GEOFF BROWN & ASSOCIATES LTD

**PERFORMANCE BASED RATE SETTING
REVIEW OF FORECAST CAPITAL EXPENDITURE FOR THE SECOND
REGULATORY PERIOD**

VISAYAN ELECTRIC COMPANY (VECO)

Prepared for
ENERGY REGULATORY COMMISSION

Figure 4.1: Normal Operating Configuration of VECO Lines 1 & 2

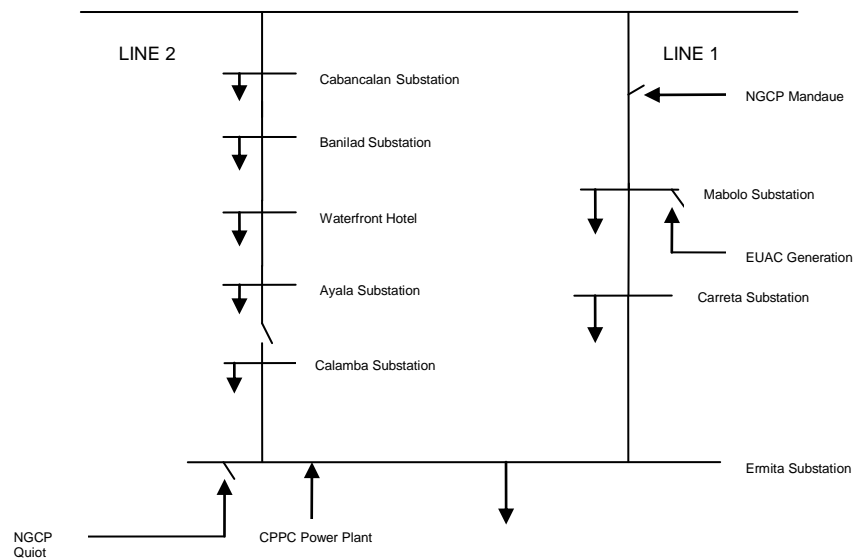
The effect of this project would be to convert the existing single bus configuration at Ermita to a double bus arrangement. VECO argues that this would provide greater operating flexibility and higher reliability, particularly after completion of its proposed 138 kV project, when incoming power from both the new CEDC plant and the existing CPPC generator will both feed into the same 69 kV bus at Ermita. As we understand VECO's argument, it is claiming that reliability will be improved by the project as the two important sources of generation can be configured to feed different bus bars.

Currently, as shown in Figure 4.1, the Ermita substation is normally energized through VECO's 69 kV line 1 but it can also be energized through Line 2. Both lines utilize 795 MCM conductor with a rating of 108 MVA and run in parallel between NGCP's Banilad substation and VECO's Ermita 69 kV substation. The network is currently operated as two radial feeders supplied from Banilad. Backup injection points from the grid are available from the NGCP Quiot and Mandaue substations but these are not used during normal operation. Additional injection is available from embedded generators

In the case of Line 1, if injection is lost from either end a line overload can be avoided by injection from the EAUC plant. This will effectively supply the Mabolo substation load and limit the remaining load to 90 MVA, which is within the line conductor rating. Sufficient injection capacity is available at either end to supply this load, although the situation would be marginal from the Ermita end if the injection capacity from Quiot is limited to the 45 MVA indicated by VECO.

Hence, while we agree that the proposed project may result in a minor reliability improvement, we do not believe that the benefit is commensurate with the project cost and therefore recommend that it not proceed during the second regulatory period. While not shown in Figure 5.1, the Ermita substation's 69 kV bus is divided into two sections, separated by a bus coupler circuit breaker. We suggest that VECO ensure that the two Ermita transformers are connected to different bus sections and that the CPPC generating station and the Quiot-Pardo-Ermita lines are also connected to different bus sections. This is consistent with good industry practice and will provide some mitigation against bus faults.

Figure 5.1: Budget and Forecast Residual Growth CAPEX (PhP Million, real)

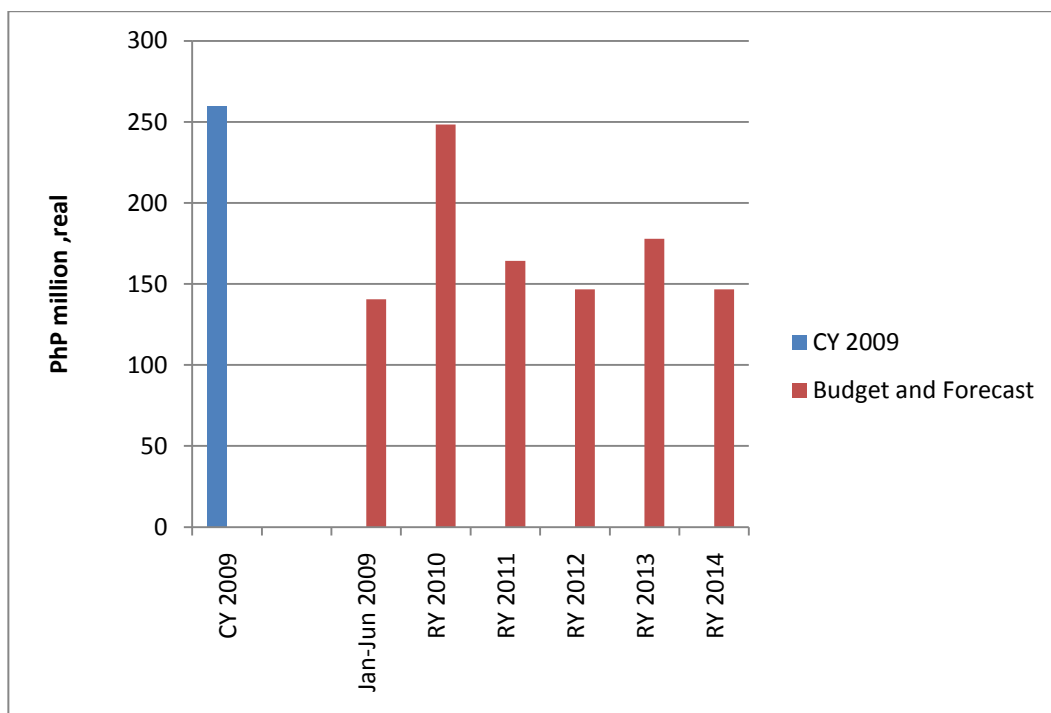
It can be seen from Figure 5.1 that VECO’s budgeted residual growth CAPEX in CY 2009 is very high compared to the majority of the forecast years, which would indicate that CY 2009 residual growth CAPEX may not be an appropriate benchmark on which to assess the residual growth CAPEX in the forecast years. This CAPEX appears to be driving high levels of expenditure forecast over the period January 2009–June 2010 and the reason for this is considered below.

Figure 5.3: Budget and Forecast Residual Renewal CAPEX (PhP Million, real)

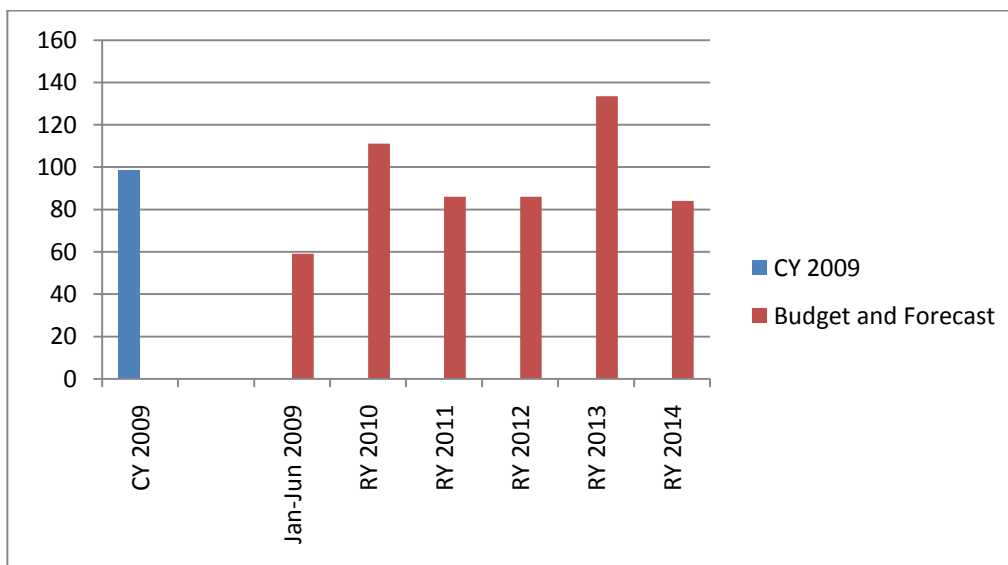
It can be seen from Figure 5.3 that, when compared to the benchmark CY 2009, VECO's forecast expenditure in RY 2010 and RY 2013 is high. Forecast expenditure in other years is more reasonable.

Figure 5.5: Budget and Forecast Residual Refurbishment Capital Expenditure (PhP Million, real)

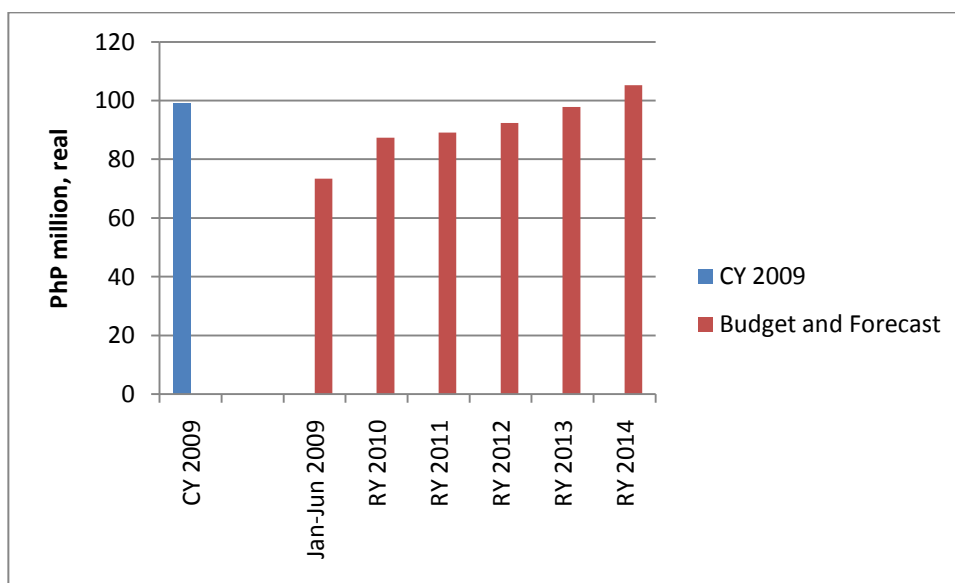
We are surprised that overall expenditure on refurbishment is higher than renewal, since we would normally expect it to be significantly lower. Unfortunately we have not explored

this in detail with VECO but note that it could be related to the way it defines expenditure for cost allocation purposes²⁵. We also note the relatively high expenditure budgeted for Jan-June 2009 (which accounts for the high level of benchmark expenditure in CY 2009) and the progressively increasing level of expenditure over the forecast period. We note that VECO has provided no information in its revenue application to justify this expenditure.
